CITY OF ALBUQUERQUE

Re: Musket Development
1615 8th St., NW
30-Day Temporary Certificate of Occupancy- Transportation Development
Engineer's/Architect's Stamp dated 10-6-15 (J14-D175)
Certification dated 2-24-16

**RE: SITE PLAN FOR BUILDING PERMIT CERTIFICATION
CERTIFICATION FOR PERMANENT CERTIFICATE OF OCCUPANCY
MUSKET DEVELOPMENT, 1615 8TH ST NW**

ENGINEER'S SEAL RONALD R. BOHANNAN NEW MEXICO P.E. #7868	MUSKET DEVELOPMENT 1615 8th STREET NW TRAFFIC CIRCULATION PLAN	DRAWN BY pm DATE 10-6-15 DRAWING 2015014-TCL
	TIERRA WEST, LLC 5571 MIDWAY PARK PL NE ALBUQUERQUE, NEW MEXICO 87109 (505) 858-3100 www.tierrawestllc.com	SHEET # TCL-1 JOB # 2015014

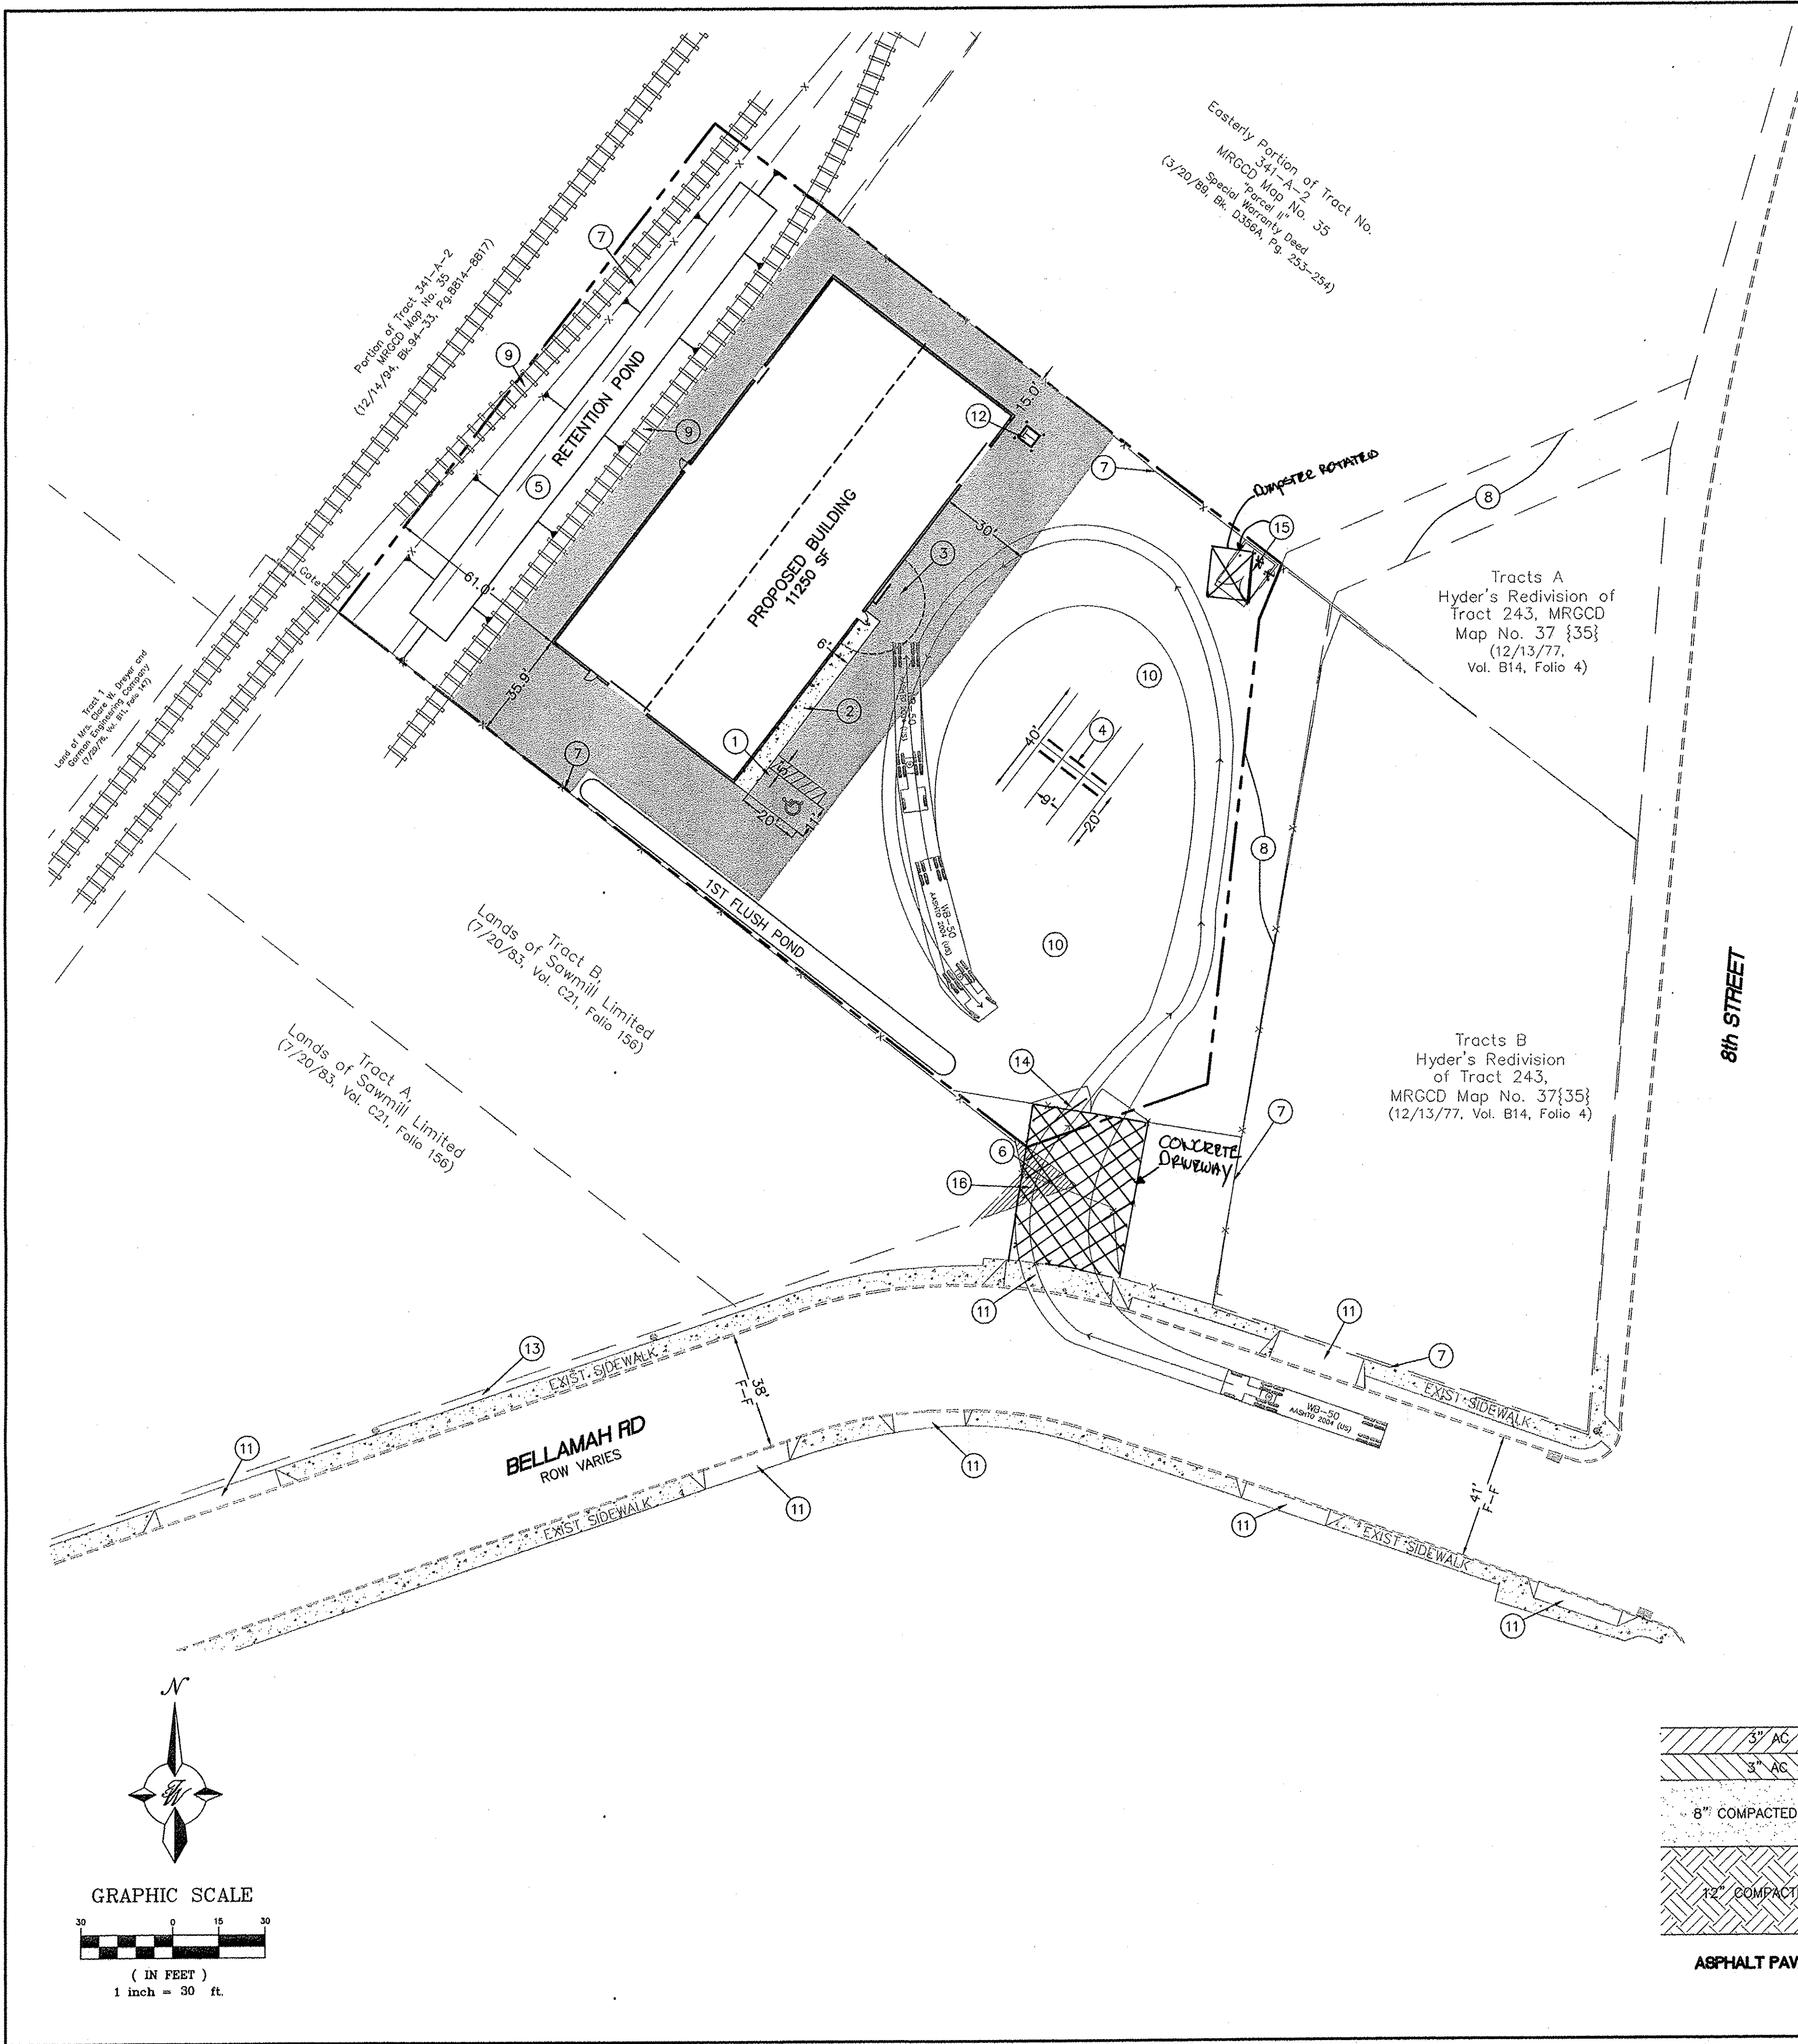
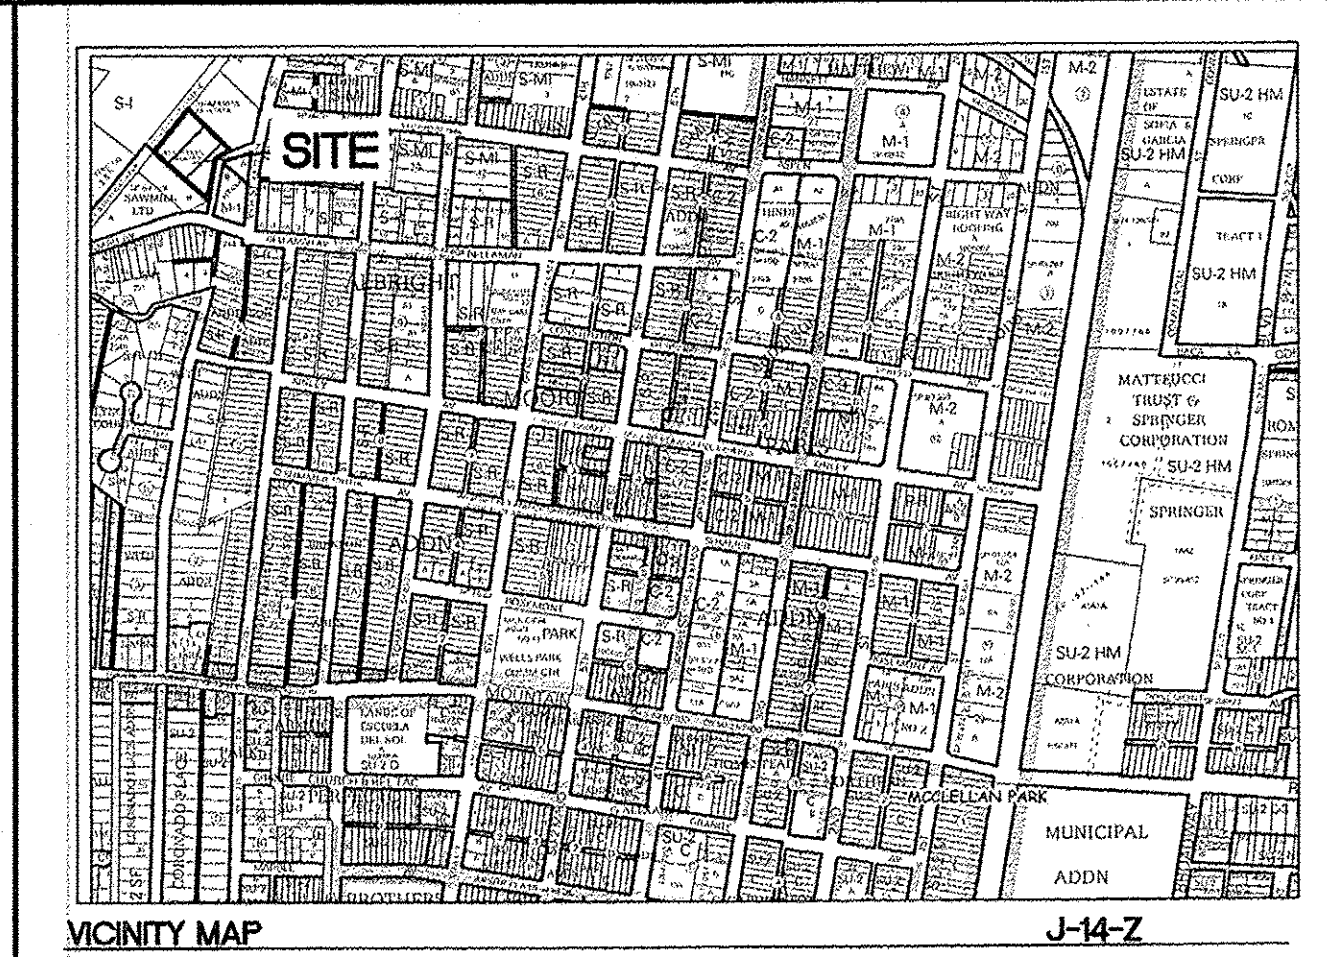
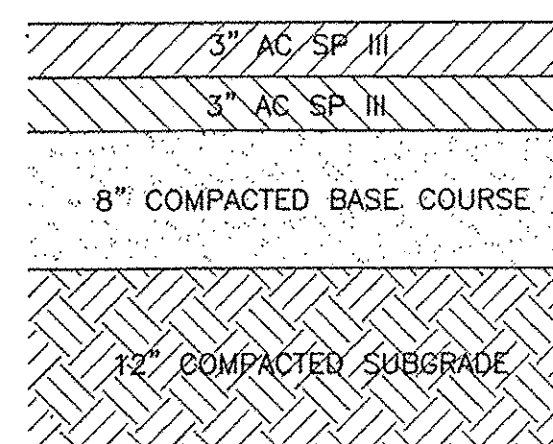
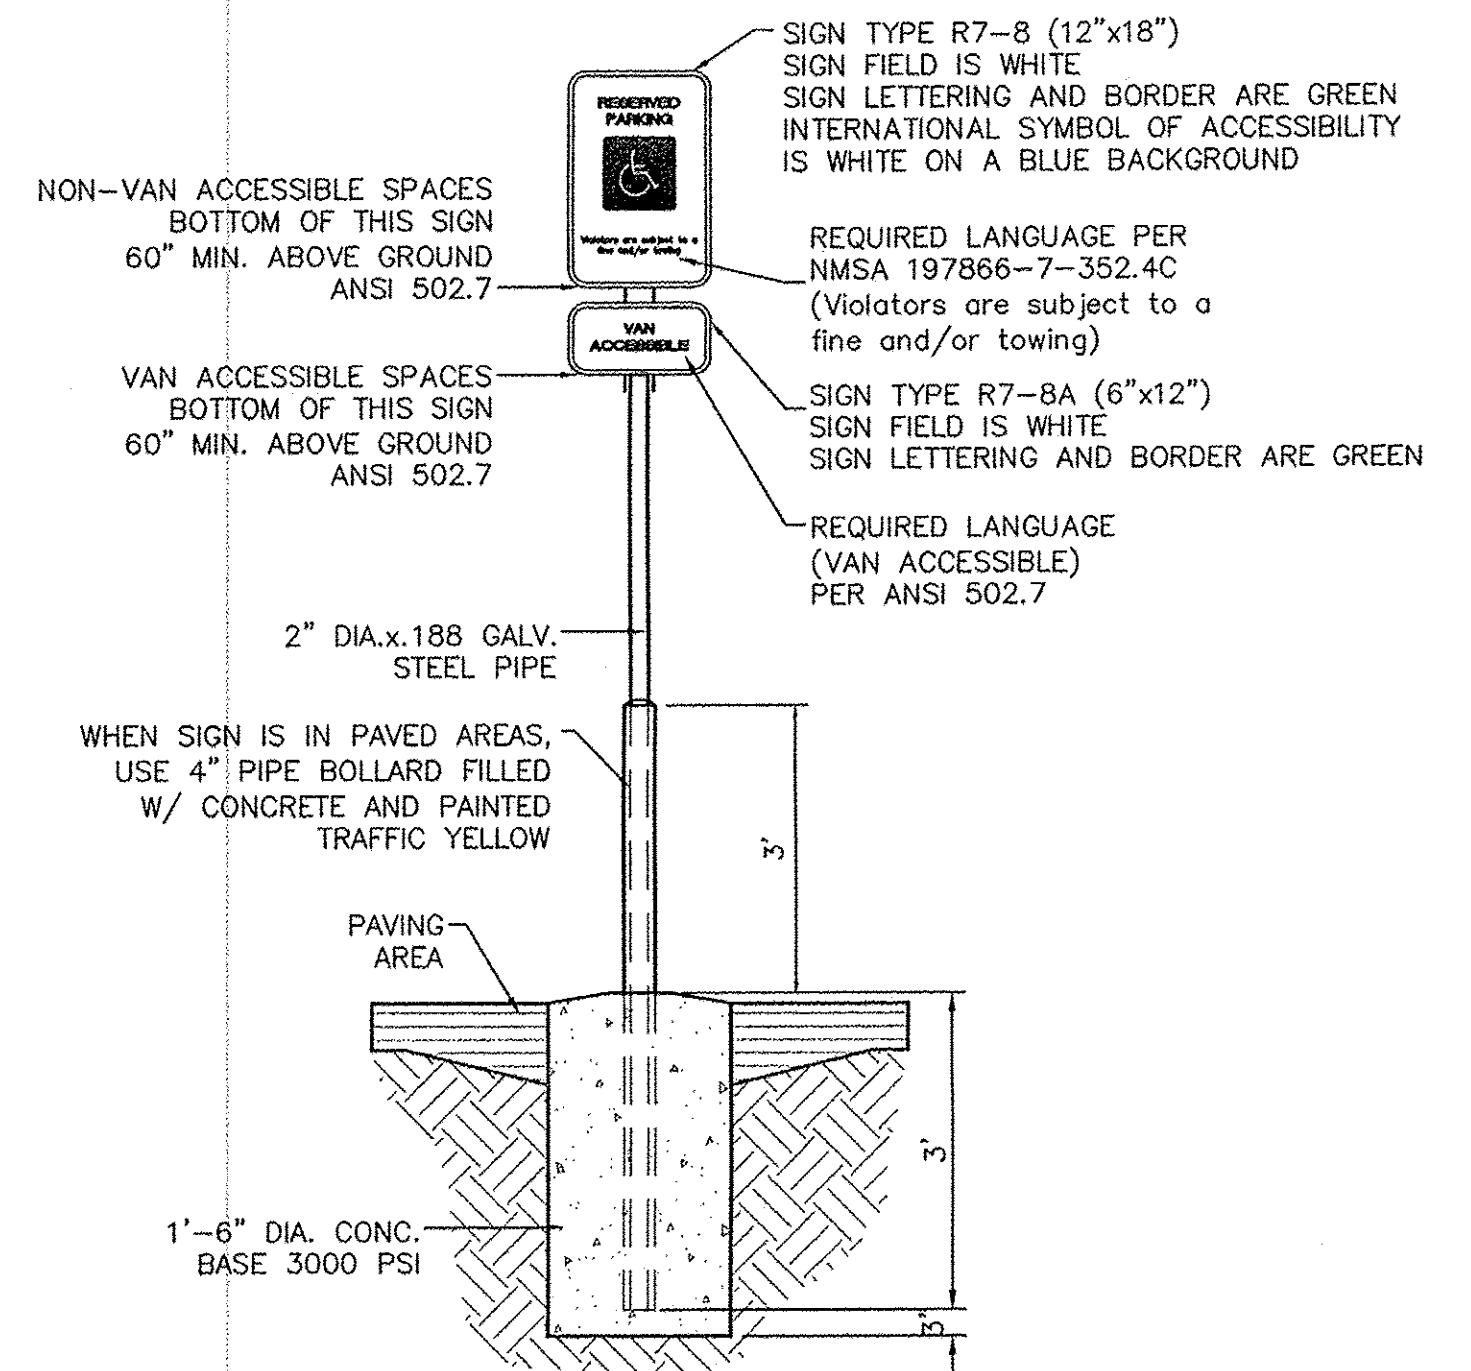
- The ADA access aisle shall have the words "**NO PARKING**" in capital letters, each of which shall be at least one foot high and at least two inches wide, placed at the rear of the parking space so as to be close to where an adjacent vehicle's rear tire would be placed. (66-1-4.1.B NMSA 1978)

ACCESSIBLE PARKING LOT SIGN

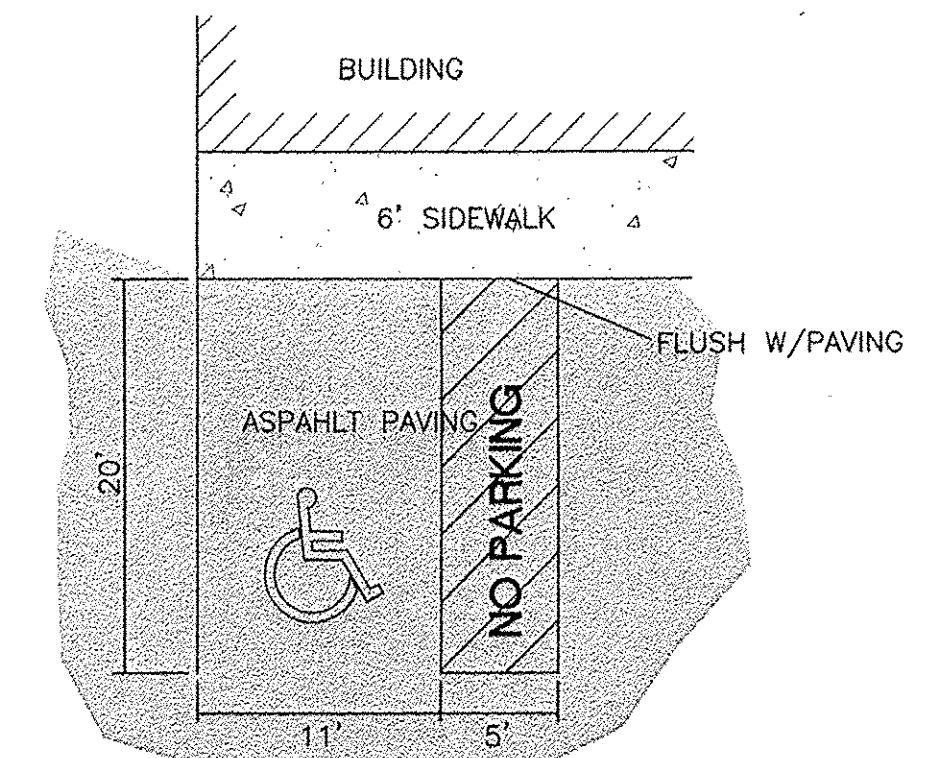
- The ADA accessible parking sign must have the required language per 66-7-352.4C NMSA 1978 "**Violators Are Subject to a Fine and/or Towing.**"
